ROCKPro64 Engineering Change Notice

ECN:20180628RP01

This ECN applies strictly to ROCKPro64 Board ver. 2.0, dated 2018-04-11. It is applicable to boards with both 2GB and 4GB memory.

(Fig. 1. Component Schematic and Layout extracts depicting location of R89538 resistor)

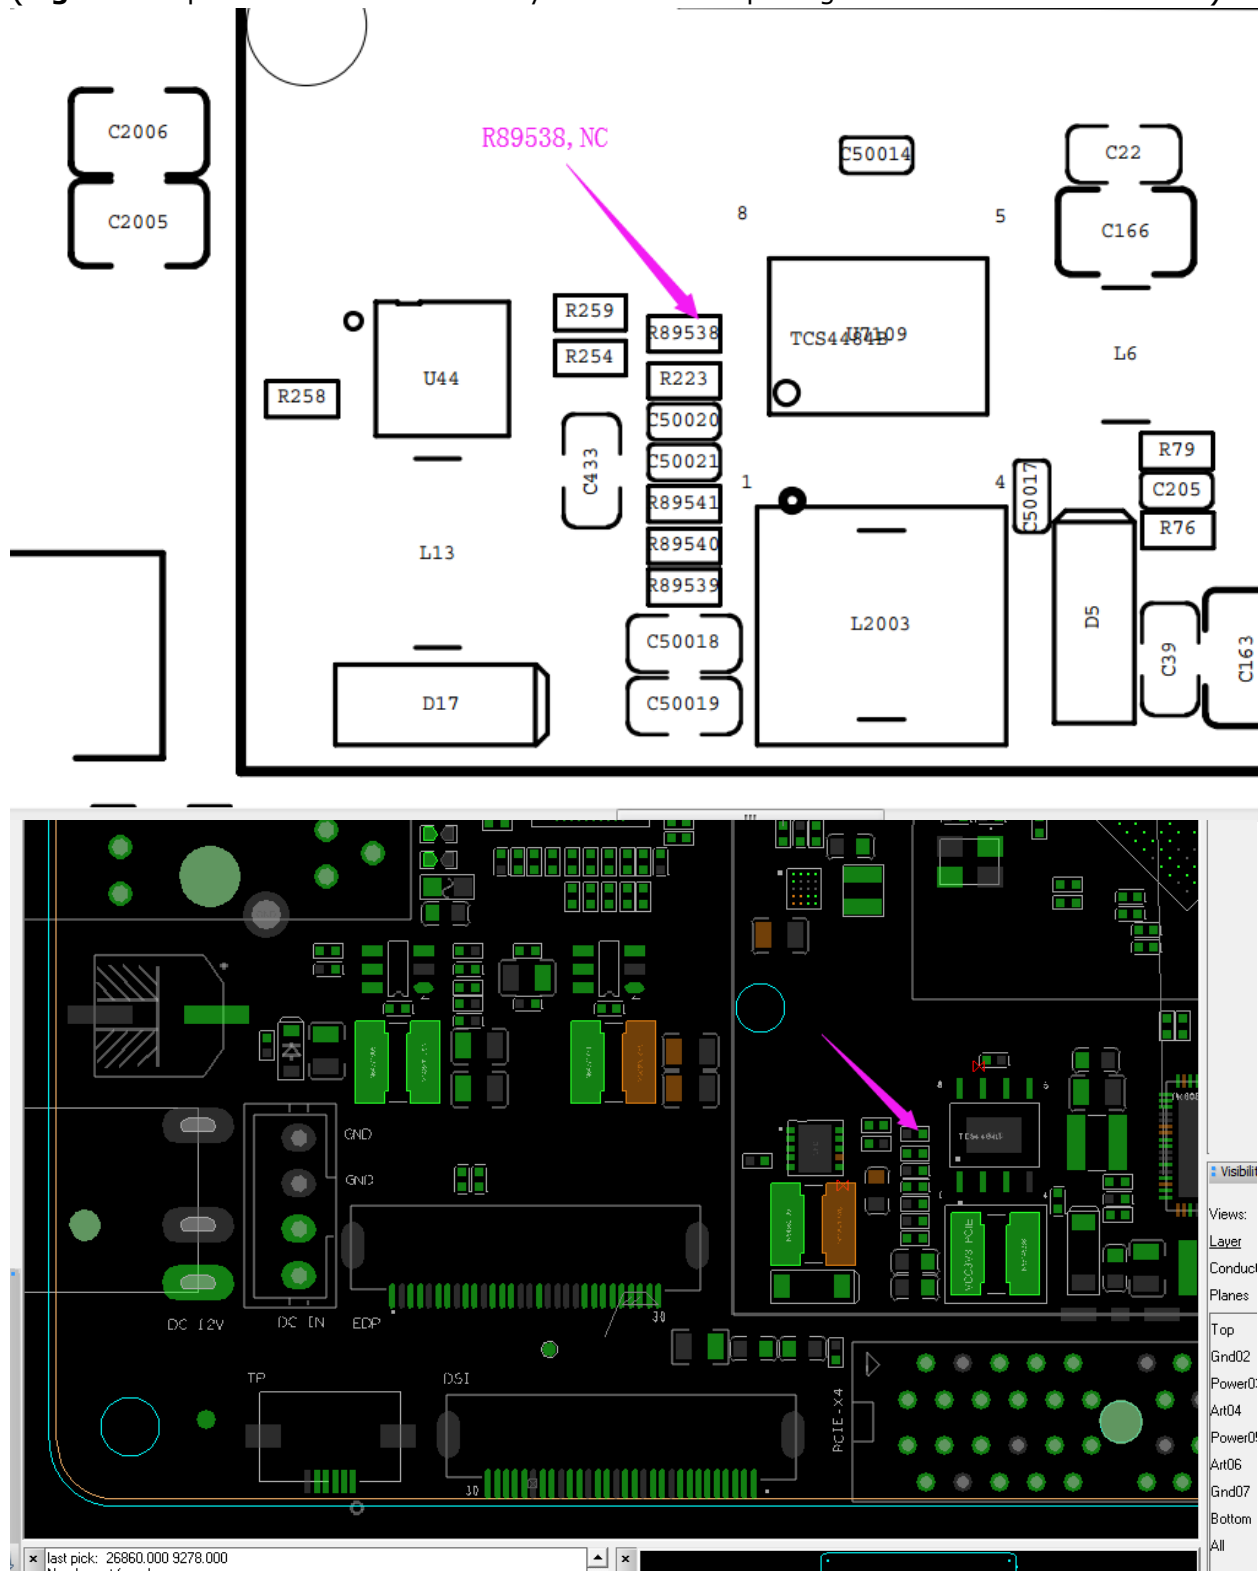
Issue: The PCIe 3.3V power is not supplied; in result PCIe is not functional.

Solution: Remove R89538 resistor that affects U7109 TCS4484B power regulator, supplying 3.3V to the PCIe Bus.
